*A People Place, A Change of Pace*  
**SHELBURNE**  
ONTARIO, CANADA

**Report:** P2026-06

**Subject:** **Sign By-law Variance Request**  
**801 Ojibway Road**  
**Fieldgate Commercial**

# SIGN A

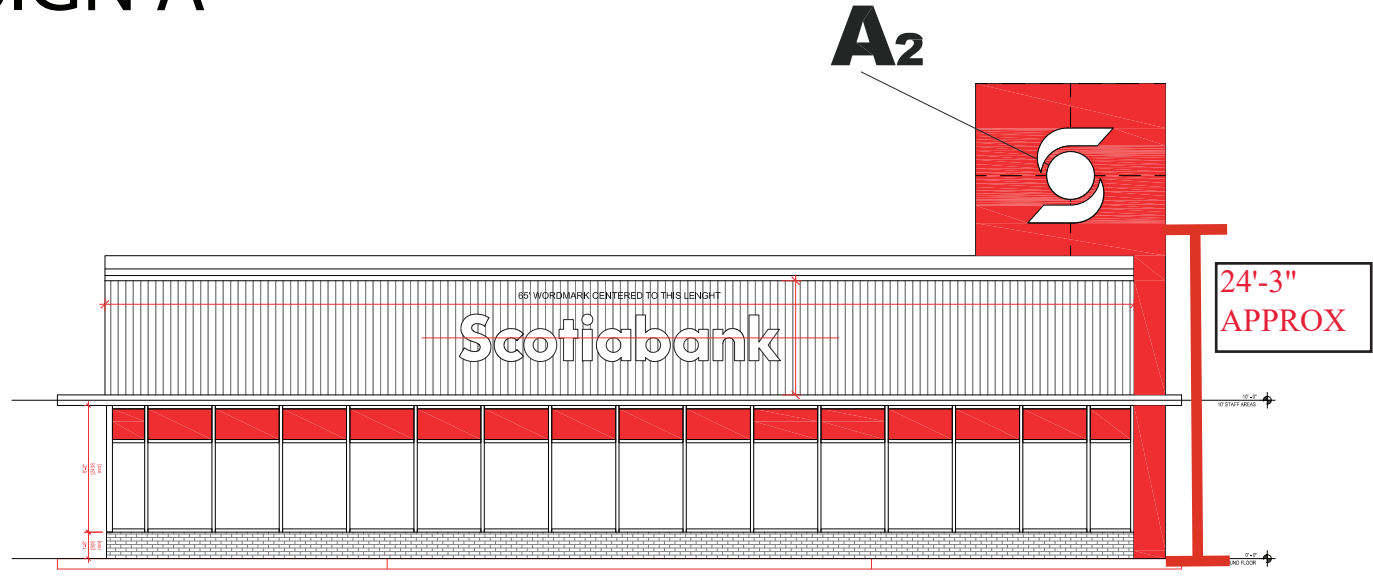
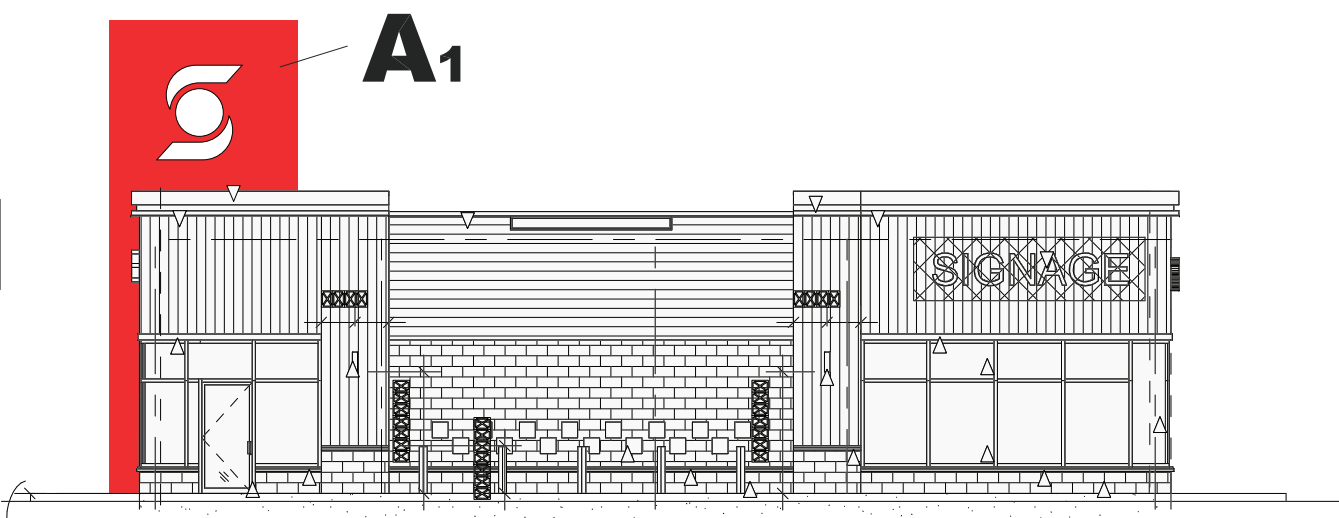
While the applicant has indicated that the proposed signage is consistent in scale with nearby developments, including the Starbucks location at the plaza across the street, staff note that the comparison is not directly equivalent. The proposed tower signage is significantly larger in scale (nearly double the size of comparable signage at nearby developments such as 804 Ojibway) and represents a greater proportion of the tower façade. Although other developments, such as McDonald's, include prominent branding elements, these are generally smaller in overall sign area relative to the structure and have been designed in a manner that is more proportionate to the building form.

In addition to scale concerns, the proposed illumination is not supported. The intensity of the lighting, particularly if maintained outside of business hours, is considered excessive and may result in undue visual impact on the surrounding area. Should the signage be supported, staff would expect illumination to be significantly reduced or turned off during non-operational hours; however, even with such mitigation, the overall impact remains a concern.

Staff acknowledge that the tower feature was purpose-built to accommodate signage. However, this does not in itself justify the scale proposed. Signage should remain subordinate to the building architecture, and in this case, a reduced size would be more appropriate and consistent with the intent of the By-law.

Based on the above, staff are not supportive of the requested variance, as it does not maintain appropriate scale, the lighting is excessively bright, it creates visual impacts and does not uphold the intent of the Sign By-law with respect to consistency and fairness within the commercial area.
